Addendum to IFB

IFB NUMBER: IFB 24-065/MR
IFB TITLE: Jefferson County Doggett Park Midway Rehabilitation
IFB DUE BY: 11:00 am CT, Wednesday, November 20, 2024
ADDENDUM NO.: 1
ISSUED (DATE): November 14, 2024

REV 1 Addendum #1 Modifications
11-13-2024

REV 1 ADDENDUM #1 MODIFICATIONS
ADDITION OF UTILITY ISLAND
DETAILS & OTHER MISC. MODS
11-13-24

JEFFERSON COUNTY ENGINEERING DEPARTMENT JEFFERSON COUNTY COURTHOUSE 1145 PEARL STREET, 5TH FLOOR BEAUMONT, TEXAS 77701 PHONE: (409) 835-8584 FAX: (409) 835-8718	
PROJECT: DOGETT FORD PARK MIDWAY ASPHALT REHABILITATION	
SHEET 5 OF 9	SHEET QUANTITIES 05
DRW'N. BY: G.K.	
CHK'D. BY: M.F.

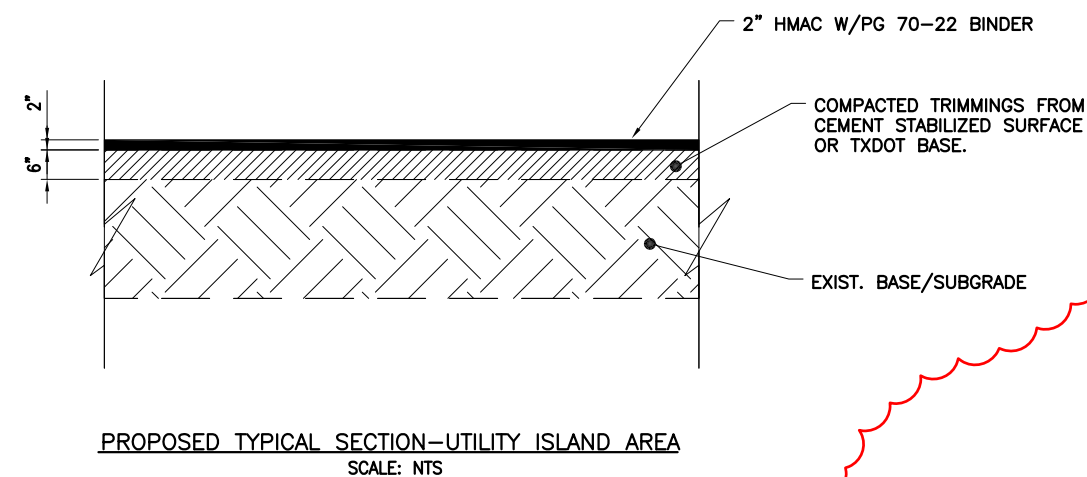
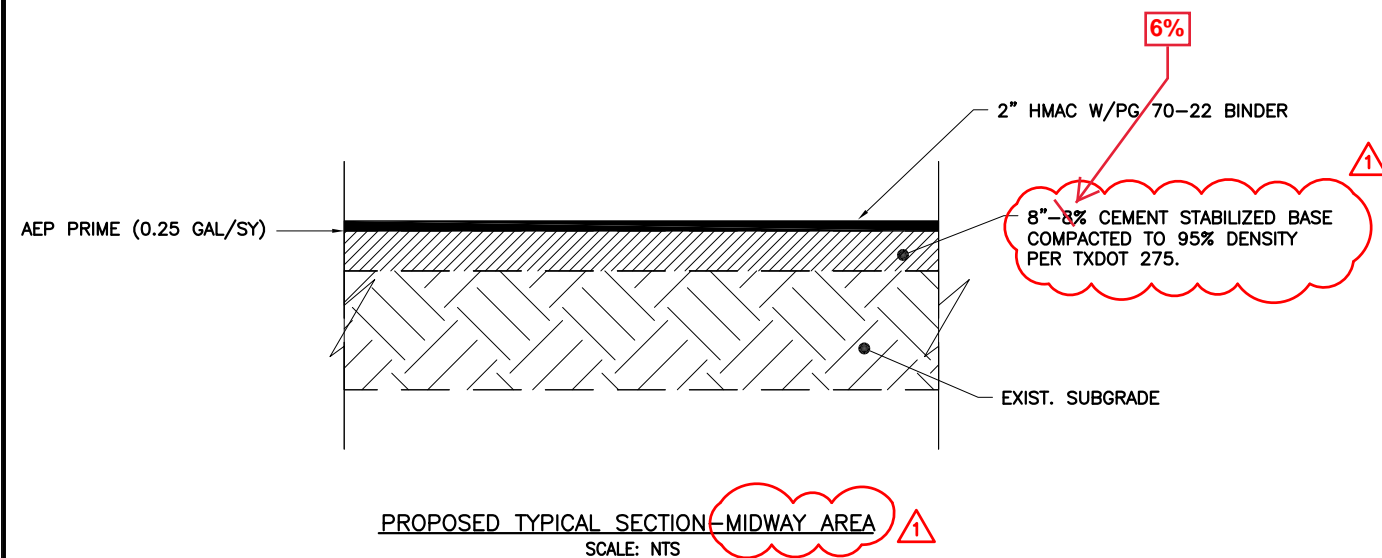
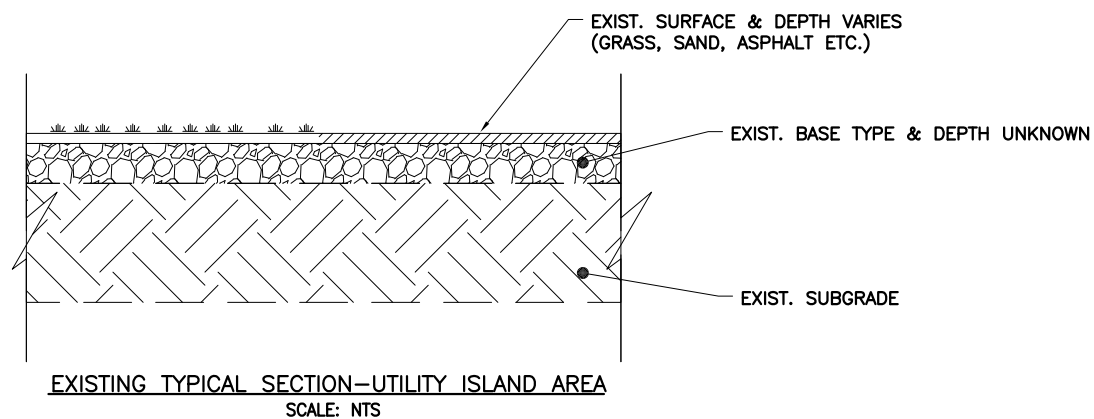
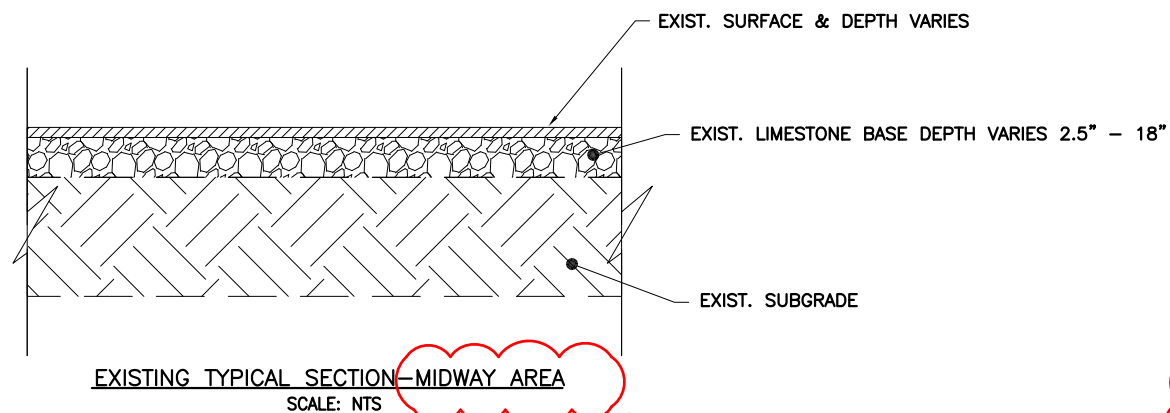
SQUARE YARDS OF SURFACE (SY) 39,900.0
EXCAVATION (INCHES) ~~2.25~~ 2.75
CEMENT LIME STABILIZATION (INCHES) 8.0
HMAC (INCHES) 2.00

Bid Item	TXDOT Item	BID ITEM DESCRIPTION	Estimated Quantities	Unit
1	500	MOBILIZATION (MAX 3%)	1	LS
2	110	EXCAVATION Excavate existing surface and base (2.25" DEPTH) Stockpile on site	3048 2494	CY
3	251	REWORKING BASE COURSE (10" 8" DEPTH)	39900	SY
4	275	CEMENT TREATED SUBGRADE (Site Mixed 8" deep) 6% (TON)	1021	SY TON
5	300	AEP PRIME (0.25 GALLONS/SY)	9975	GAL
6	340	DENSE GRADED HOT-MIX ASPHALT 2 inches thick, PG 70-22 (20% RAP Allowed)	4608	TON
7	351	FLEXIBLE PAVEMENT SUBRADE REPAIR	400	SY
8	502	BARRICADES AND TRAFFIC/PEDESTRIAN HANDLING	1	LS
